**Safety Evaluation Report  
License Amendment for the Crow Butte Resources  
Marsland Expansion Area In-Situ Recovery Project  
Dawes County, Nebraska**

Materials License No. SUA-1534

Docket No. 040-8943

Crow Butte Resources, Inc.

Figure 2.3-1 2014 Seismic Hazard Map of the United States showing peak ground acceleration for ten-percent probability of exceedance in 50 years (USGS, 2014).

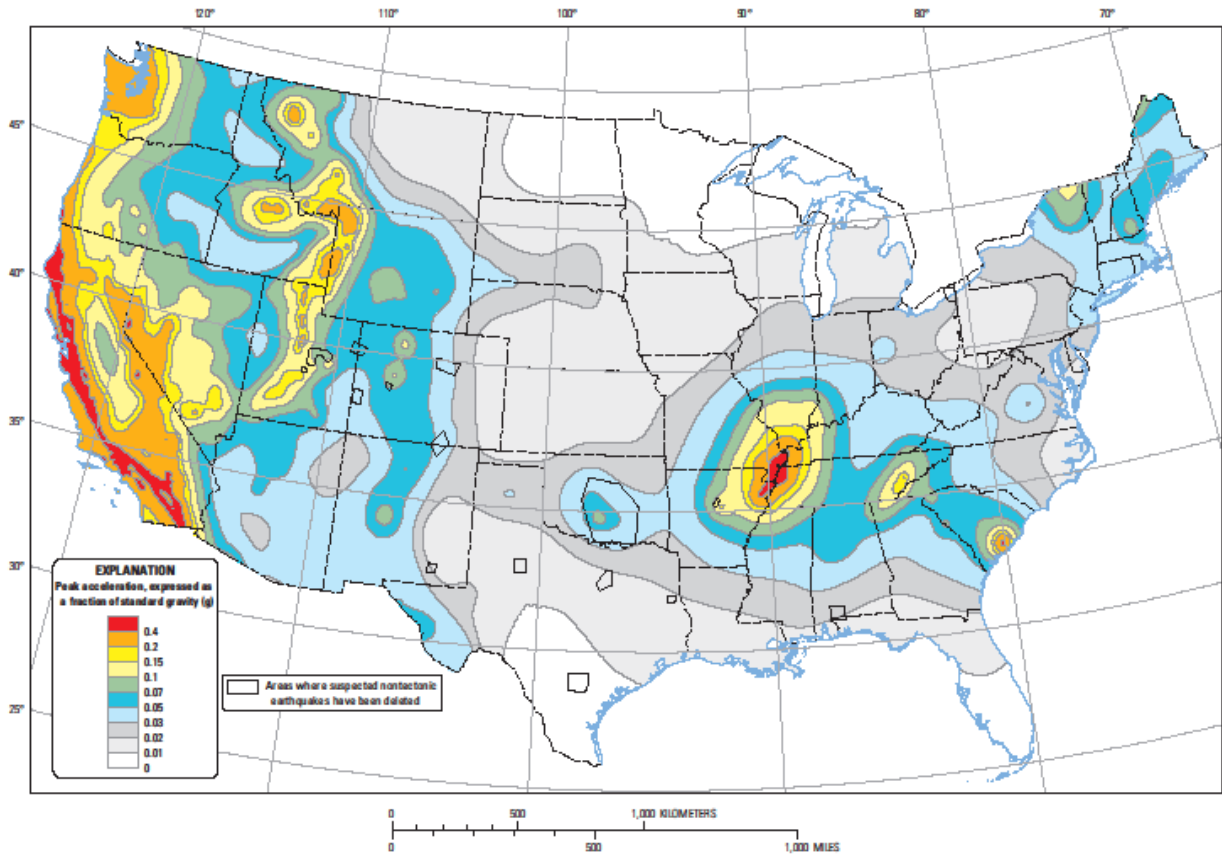
Figures 2.6-17 and 2.6-18 in the MEA TR (CBR, 2015) present 2008 seismic hazard maps for the United States and Nebraska that show expected ground accelerations during earthquakes based on a 10 percent probability of exceedance in 50 years (equivalent to an occurrence rate of once every 475 years). Figure 2.3-1 shows the most recent version of the USGS National Seismic Hazard map (USGS, 2014), which is essentially the same as Figure 2.6-17 for the region around the MEA. Figure 2.3-1 shows that the MEA is located in a region with peak acceleration about 2-5% g, where g is the acceleration due to gravity (equal to 9.8 m/s<sup>2</sup> or 32.2 ft/s<sup>2</sup>). This range of peak accelerations is considered very low in the United States. Therefore, the information in the seismic hazard maps supports the conclusion that the MEA is located in an area with low seismic hazard.
